Addendum No. 1

May 16, 2023

129th Avenue & King Road Utility Undergrounding CIP-11-22

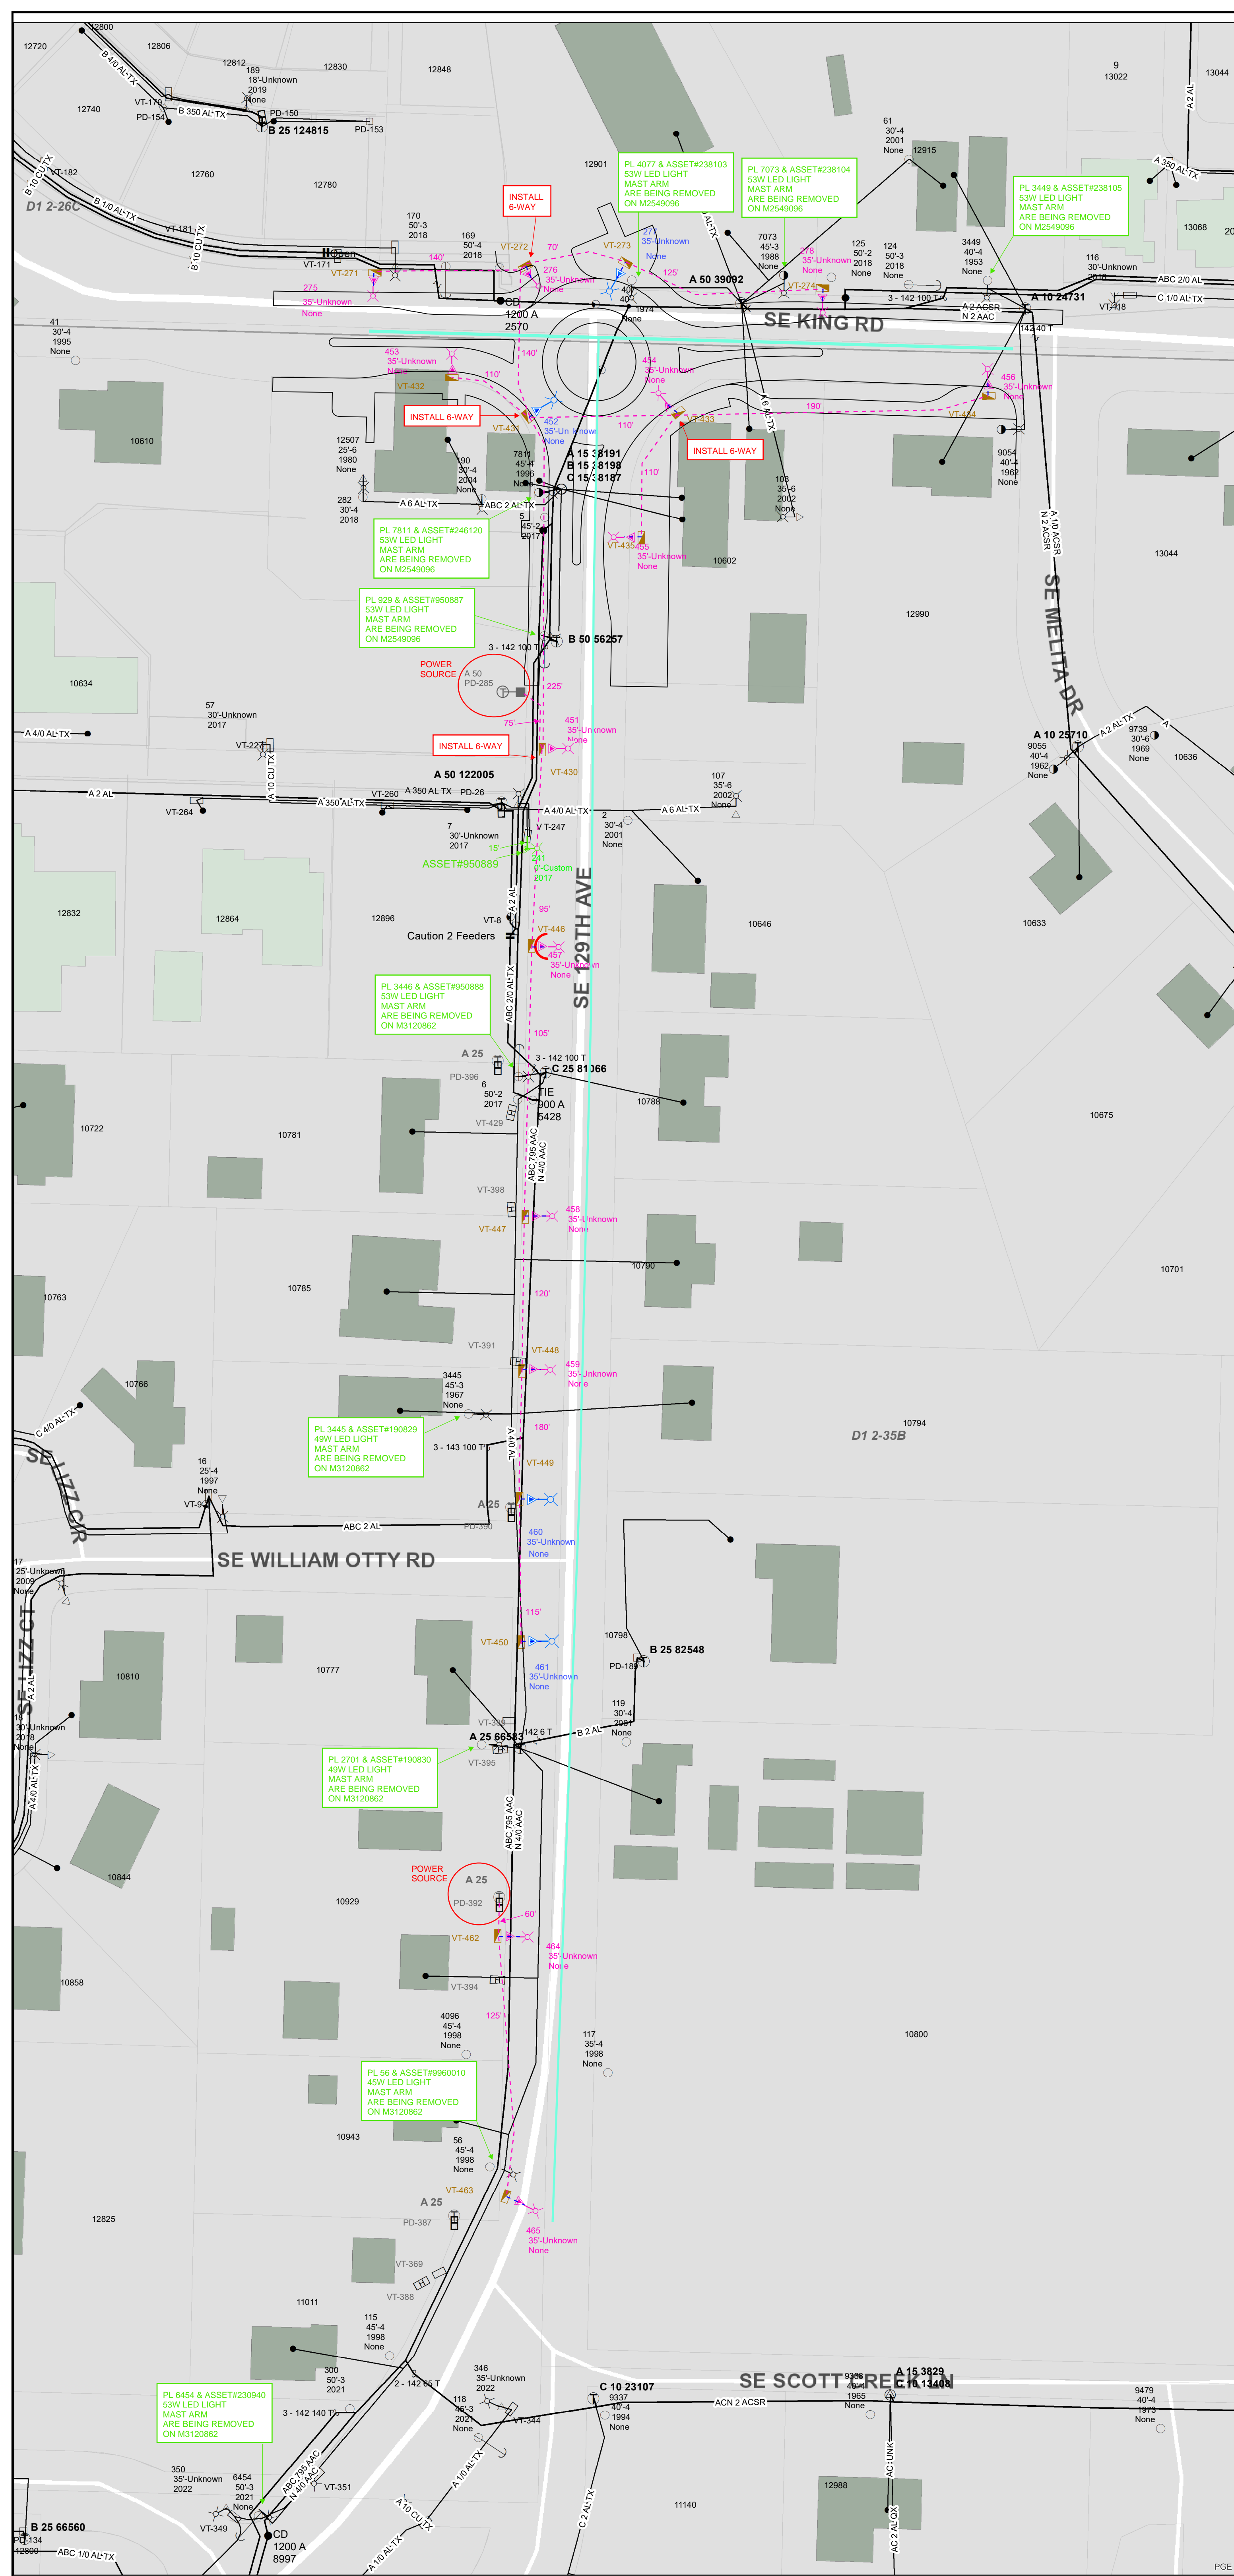
2. Question from Contractor: *“There are several new light poles on C2.0, 2.1 & 2.2 that all have note 41 and note 41 says to see lighting plan for details. I don’t see any lighting plans for typical installation details or a luminaire schedule.”*

The following documents are to be considered as part of the approved plans and are included as part of this addendum:

- PGE Lighting Plan
- PGE Statement of Streetlight Installation Responsibilities (Project to follow Option A)
